**APPLICATION FOR
HISTORIC AREA WORK PERMIT**
HISTORIC PRESERVATION COMMISSION
301.563.3400

Building Number: 10305 Street: ARMORY AVENUE
Town/City: KENSINGTON Nearest Cross Street: BALTIMORE ST
Lot: 8 Block: 9 Subdivision: 0015 Parcel: _____

10305 ARMORY AVE HAWP PRELIM SUBMISSION

Please find attached response to staff comments provided on April 9, 2024

1 EXST FRONT ELEVATION
A102
3/16" = 1'-0"

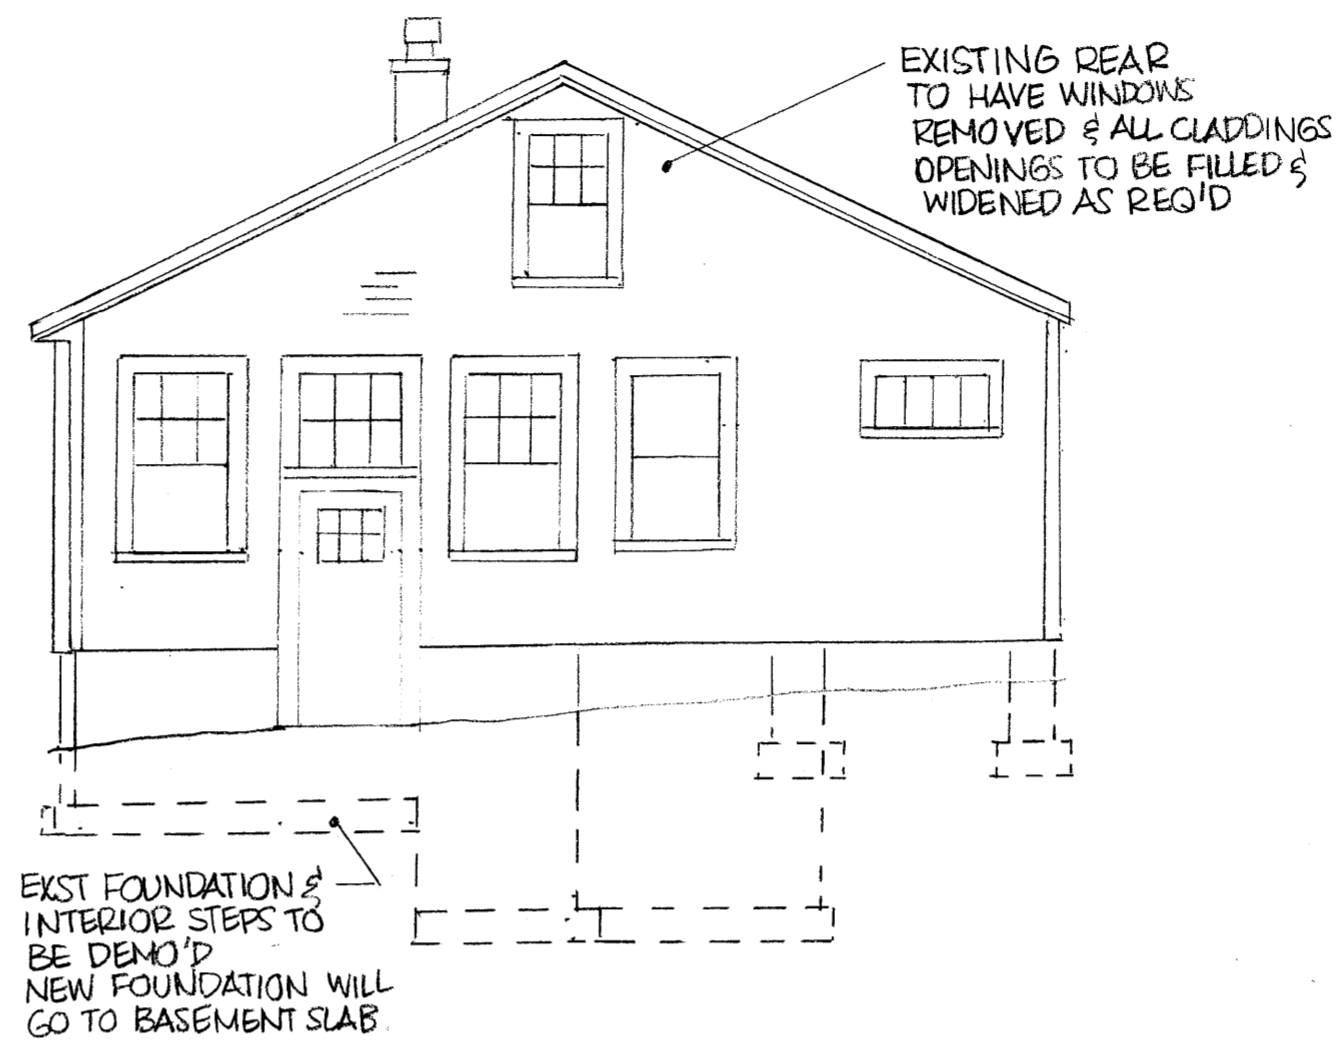
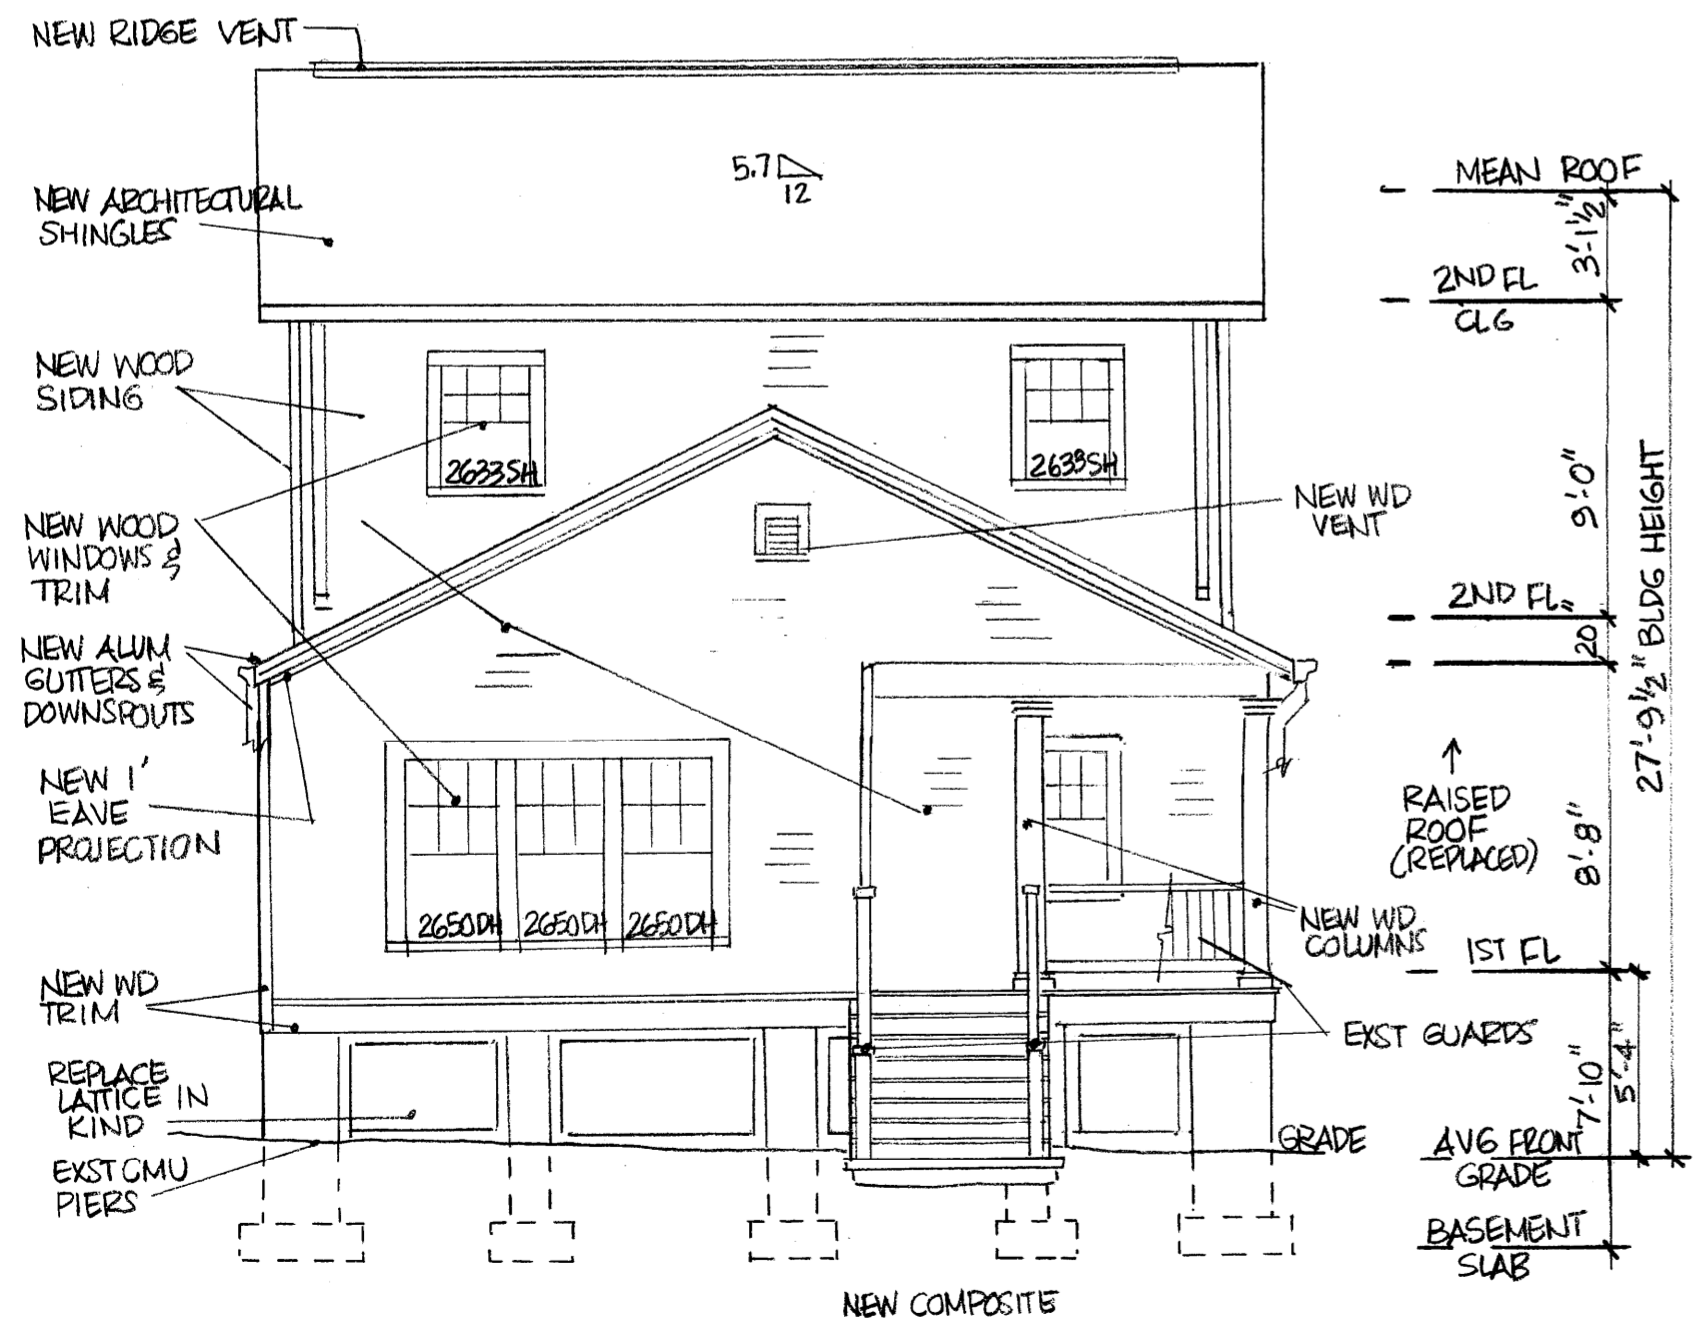
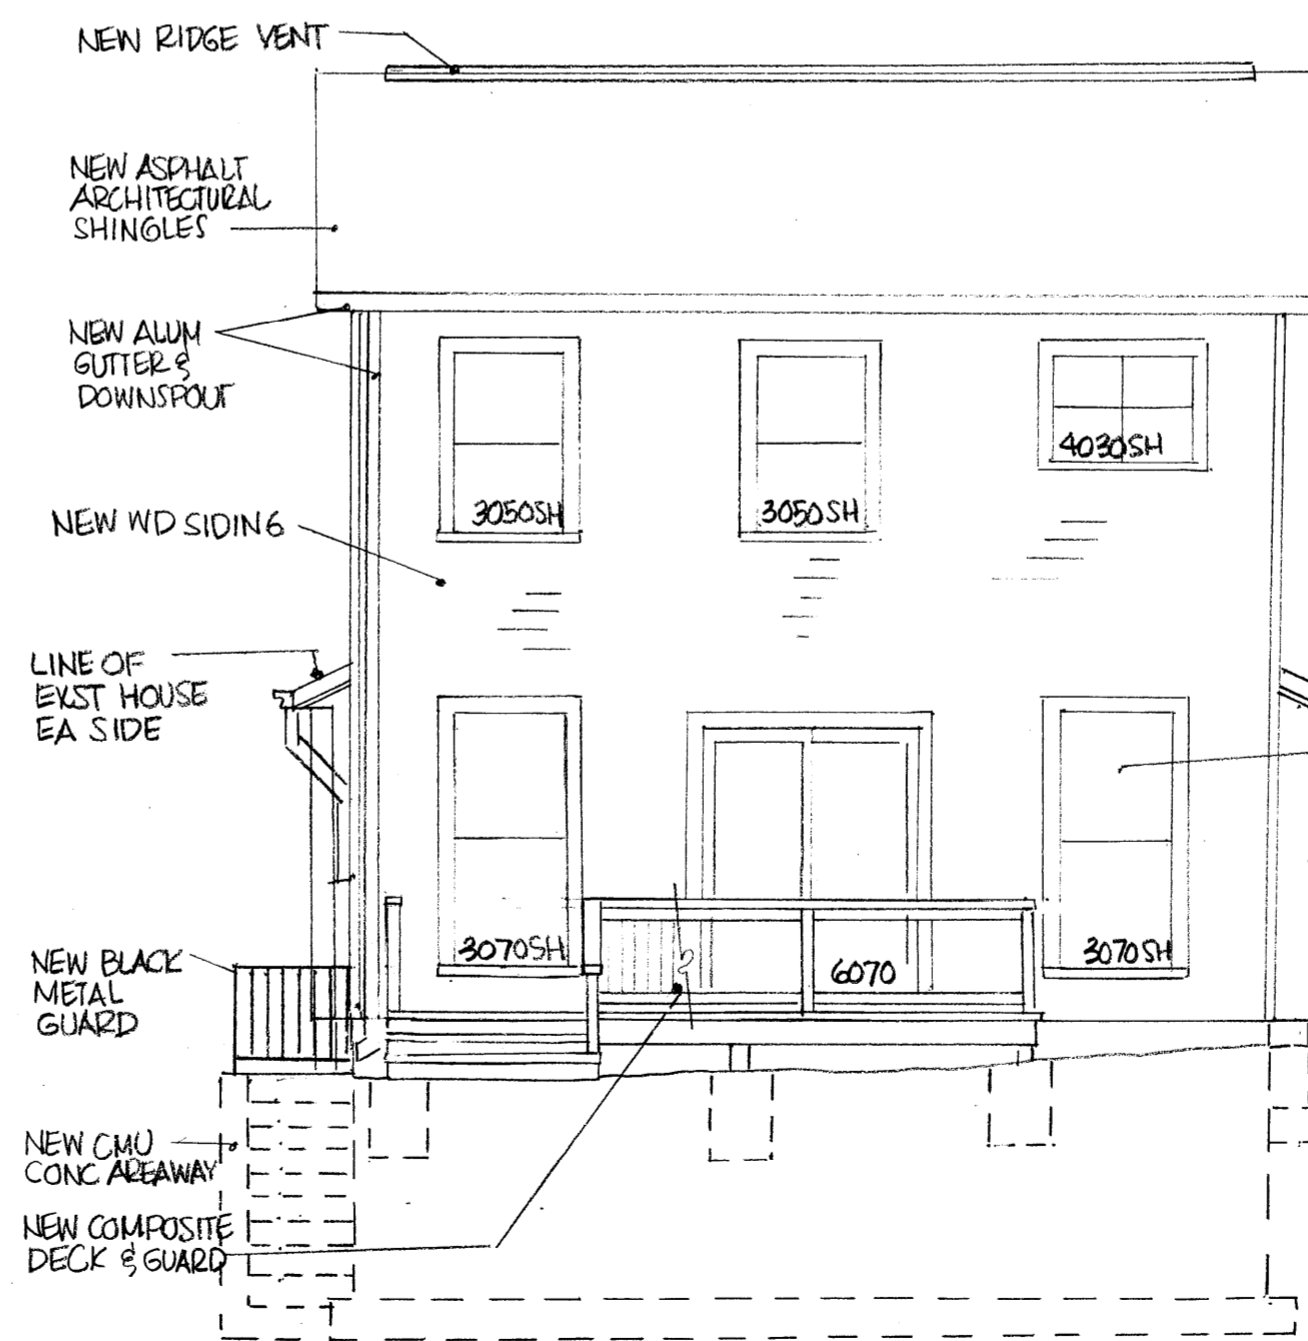
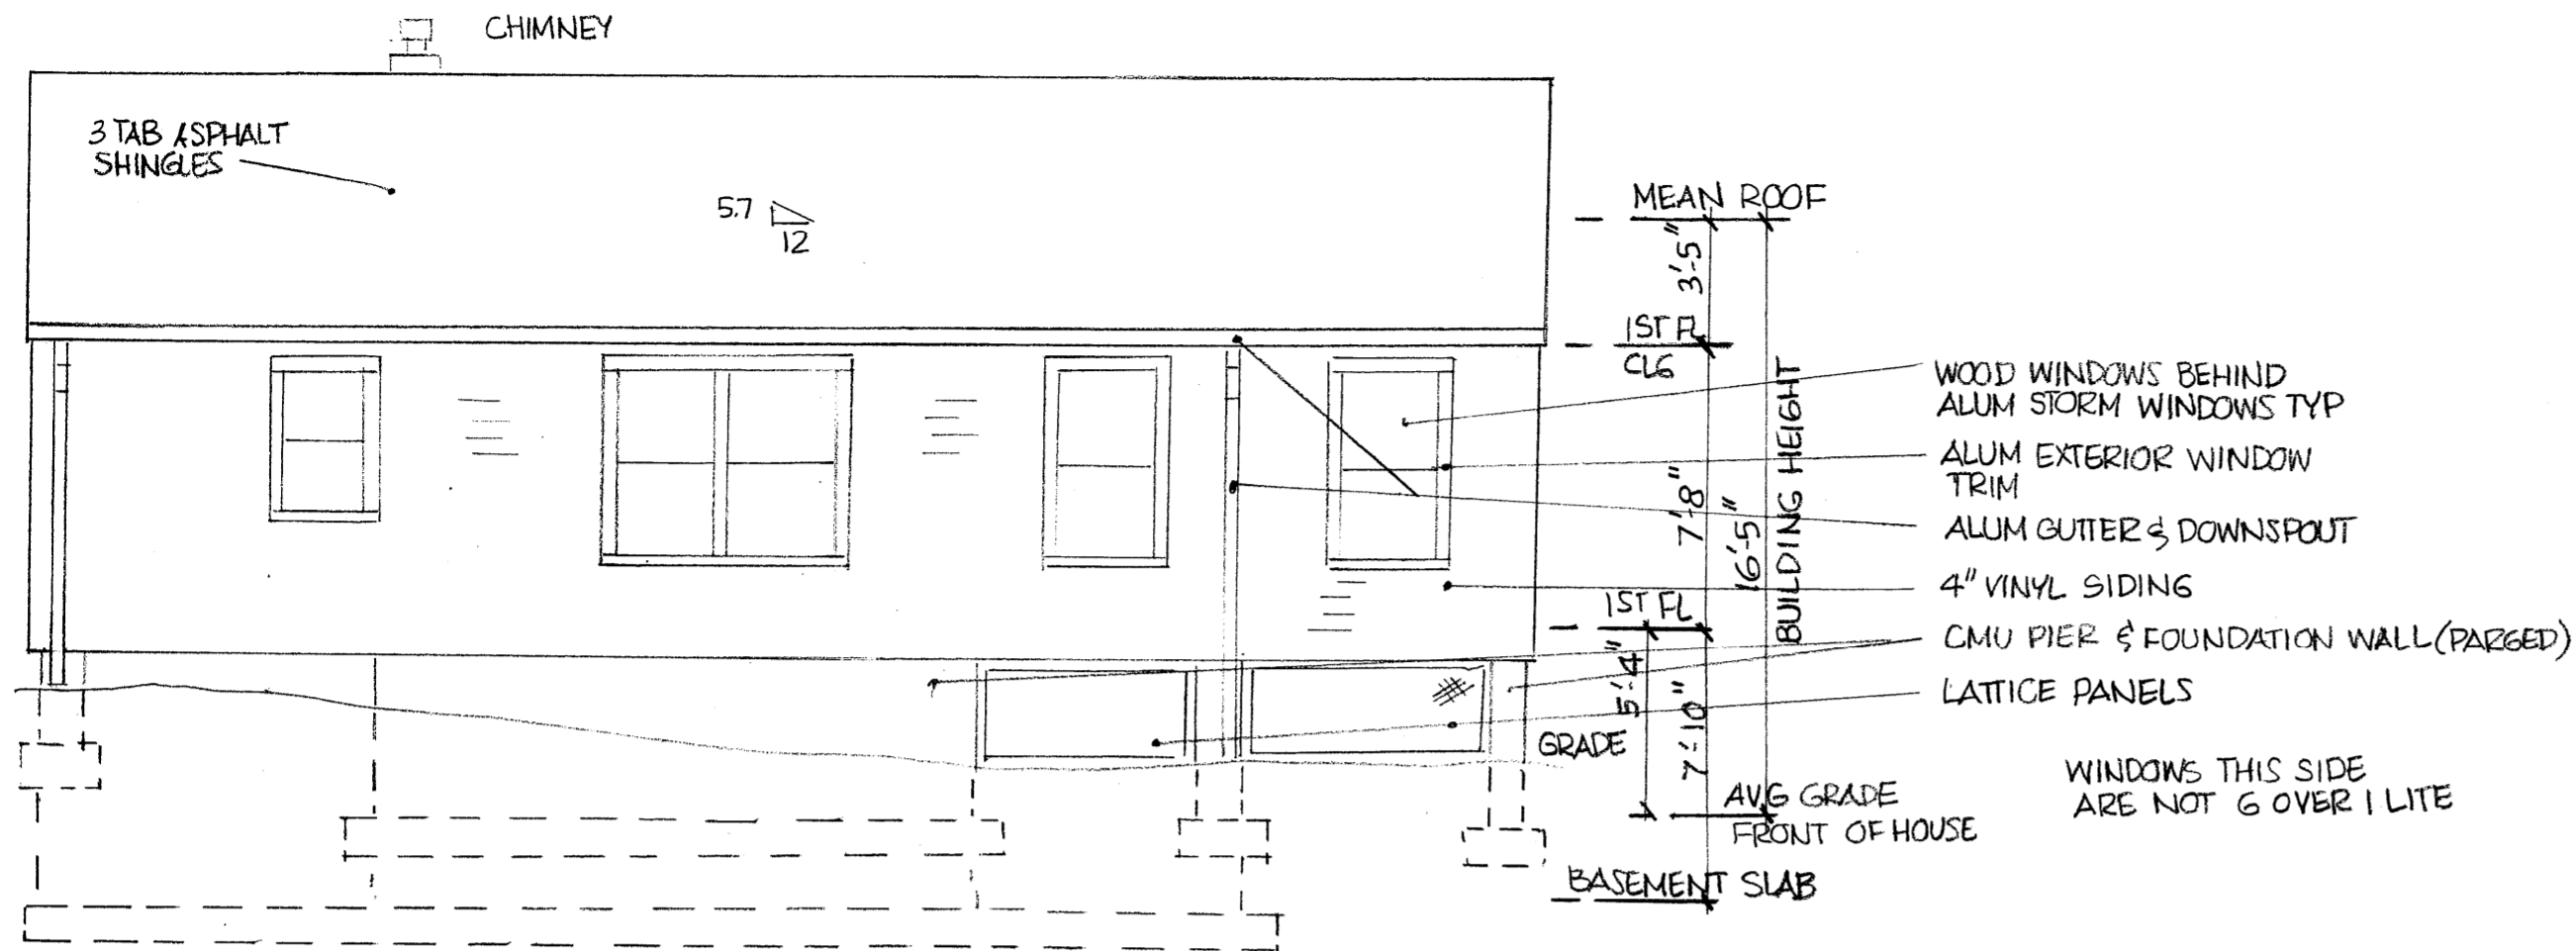
We do not support raising the roof. Please provide justification why it is necessary if you would like to pursue that. As an alternative, you may consider digging a larger basement space. [THE OWNER/CONTRACTOR FEELS THE ROOF STRUCTURE NEEDS TO BE REPLACED AND NOT REPAIRED, SO WAS HOPING THERE WAS THE OPPORTUNITY TO RAISE THE ROOF BY ONE FOOT TO HAVE A SLIGHTLY HIGHER CEILING.](#)

- Window sizes should be maintained on the front elevation. Ideally, the windows on the side elevations will remain unchanged as well. [WINDOW SIZES RETAINED EXCEPT AT EGRESS WINDOWS FOR BEDROOMS AT FIRST FLOOR AND BASEMENT.](#)

- Keep the stained-glass window in its existing location or find a location elsewhere on the house to reinstall it. [WINDOW NOW SHOWN IN EXISTING LOCATION](#)

- Add dimensions on the elevations. The height of the existing residence and proposed addition would be particularly helpful. [DIMENSIONS ADDED](#)
- A page should be provided for each elevation that shows the existing conditions and then the proposed alterations and addition for easy comparison. [EXST AND PROP ELEVATIONS NOW INCL](#)

- Include existing and proposed roof pitches on the elevations. [NOW INCLUDED](#)
- Include a detailed existing site plan with dimensions showing the current conditions and a proposed site plan. Include any changes to the site, including tree removals, drainage, etc. [EXISTING AND PROPOSED SITE PLAN NOW INCLUDED.](#)

- Increase the line weight on the elevations so they are easier to see. [ELEVATIONS DARKENED](#)
- A 3-D streetscape showing the proposed addition in scale to the adjacent properties would be helpful. [AT THIS POINT NOT PROVIDED BUT LOOKING INTO IF IT BECOMES NECESSARY.](#)
